# MOLLETT'S FARM

## Deadline 10 Submission from Mollett's Partnership (trading as Mollett's Farm)

This Submission represents our final comments for Deadline 10, taking account of comments to the Examining Authority by interested parties at Deadline 8 and Deadline 9 and to update the ExA as to further discussions with the Applicant and Suffolk County Council.

A plan showing the calculation locations of the primary assessment location in the noise calculations (Receptor 15 in the various two village bypass noise assessments) and the additional location at the southern edge of the camp-site is appended to this letter.

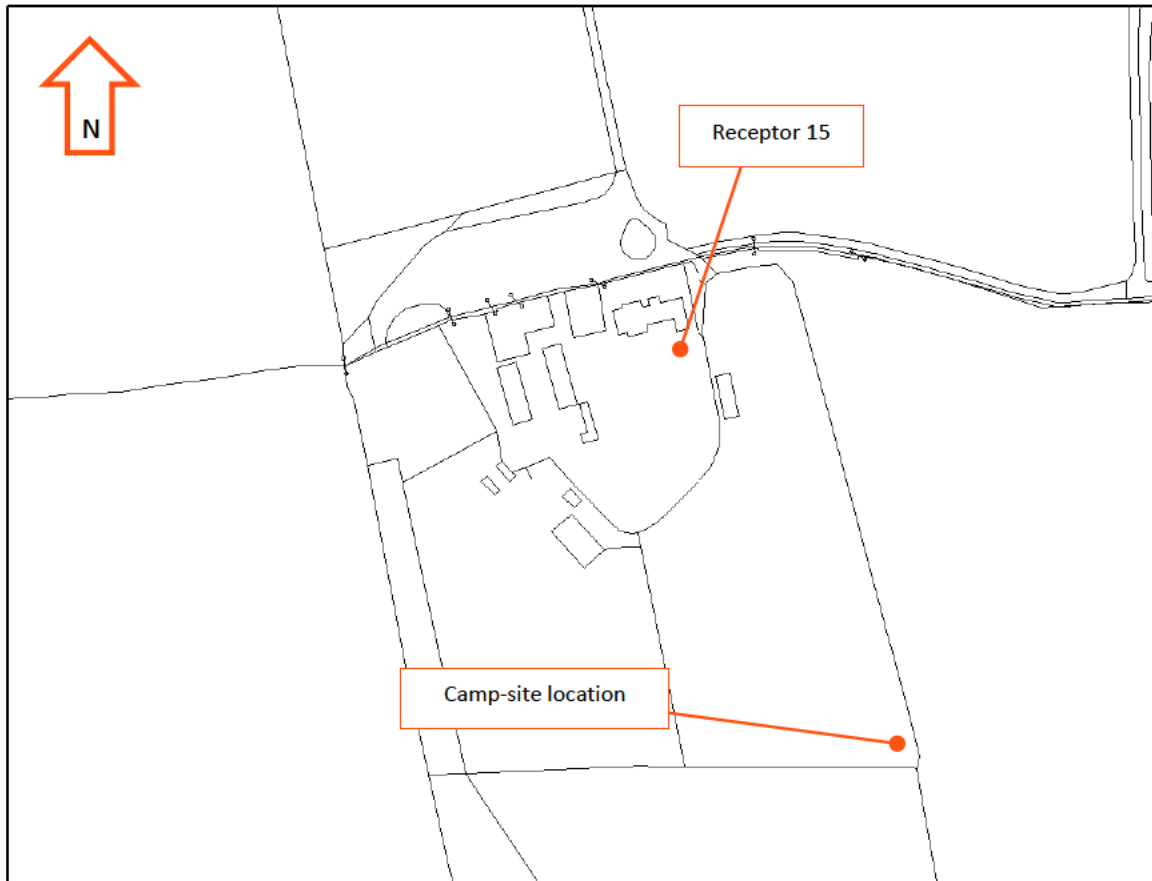
Information on the exact location of the modelling was provided in the letter of 4<sup>th</sup> October. However, we noted that the location was in the garden rather than "*on the façade facing the new or changed stretch of road*", as required by DMRB (LA111 3.53). This is significant as a façade location would be more protected from noise to the north and would be expected to give a greater difference between the existing and proposed routes than the free field location used. This in turn would give an increase in the predicted impact of the new route. We questioned this and in the letter of 7<sup>th</sup> October EDF responded that this approach had been taken "*Since SZC Co. did not have access to definitive information on the sensitivity of particular uses within a particular façade of each*

The approach to receptor locations in the noise modelling was to select a free-field location close to either the worst-affected location in a group of receptors, or close to the worst-affected façade of a single receptor. Since SZC Co. did not have access to definitive information on the sensitivity of particular uses within a particular façade of each receptor building, and since DMRB LA111 does not prescribe a specific method of selecting receptor points, this approach was considered to be the most appropriate way to capture representative effects from the project.
